Ecology response 28 10 25 for DC/25/100186 Cockpit Farm Barn, Knowle Lane, Horton Heath, Eastleigh, SO50 7DZ

Application for discharge of Conditions 8 and 9 (Drainage Scheme and Maintenance) of planning permission ref. F/23/94713 for construction of six (6) dwellings

Previous drainage proposal

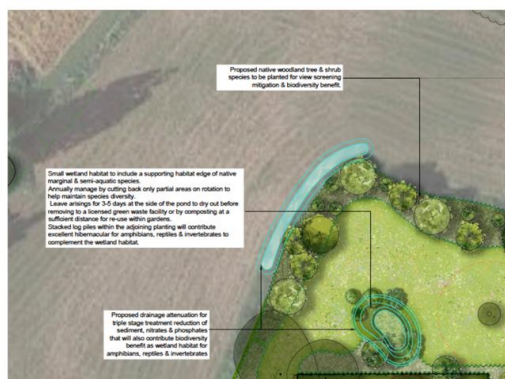
I have reviewed the Drainage Summary for Discharge of Condition (October 2025). The diagram on page 4 shows an earlier plan for the drainage basins and swales. This summary must be updated to include the current proposals shown within the current proposed landscaping plan. The drainage plan in Appendix A is also the earlier proposal.

Current drainage proposal

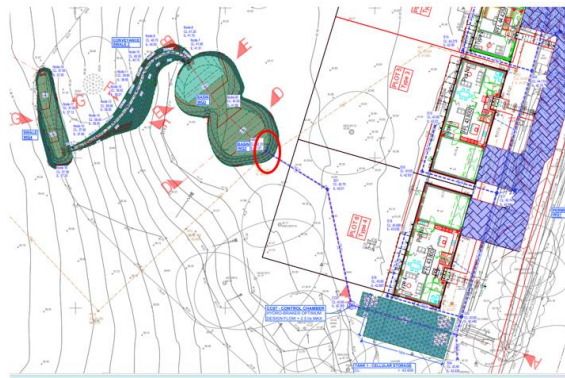
I don't see any information that addresses part f of the condition: *Exceedance plans demonstrating the flow paths and areas of ponding in the event of blockages or storms exceeding design criteria.*

It is not clear how the current drainage proposal relates to the red line boundary of the site. If the proposed attenuation tank, basins and swales are outside the red line boundary of the site, are they on land within the ownership of the applicant?

Details of how the water will end up in the proposed surface water sewer are not clear. Is a pipe proposed through the field below the site? Where is the private surface water sewer proposed to be located? Is this land in the ownership of the applicant?

In the Key Plan shown in Drainage Layouts Sheet 2 there is a red line running from the end of the Swale WQ4 to a point below the contour lines. The key shows the proposed SW Sewer as blue and the private storm drainage as blue. Are these meant to be the same pipes?

Ecology does not deal with Foul drains but there is a box labelled Foul Point of Connection at the top of Drainage Layouts Sheet 2 with an arrow that does not point to anything specific. The Private Foul Drainage line appears to cross the Surface Water Drainage line at the top of

Basin WQ2 (see red circle above). This is not acceptable. A leak in the foul drainage at that point would contaminate the basins, swale and the rest of the surface water drainage system. The foul water and surface water systems must be kept separate enough so that a leak in the foul water system cannot contaminate the surface water drainage.
